Office Action Summary

10/593,916

FURLOTTI, FILIPPO

DETAILED ACTION

Hiramoto et al. – Figure 1

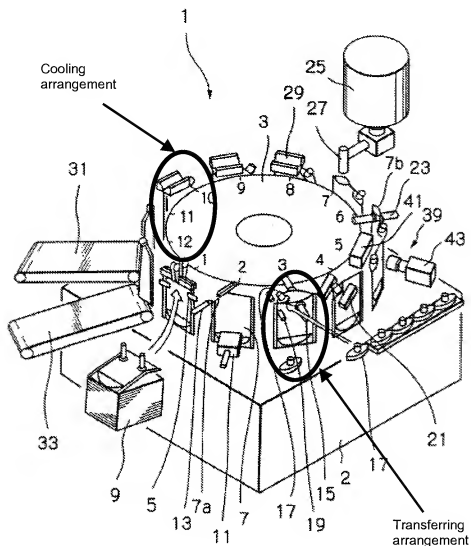
Consider claims 1, 2, 8, 20 and 26. Hiramoto et al. disclose a first embodiment of a system (1) capable of cooling a sealed portion of a container (7) comprising: a transferring arrangement (see Figure 1 below), a platform (3), and a cooling arrangement (see Figure 1 below) clearly having one or more cooling mechanisms since the sealed portion of the container (7) is cooled at step (10) (col. 4, L 13-59; Fig. 1).
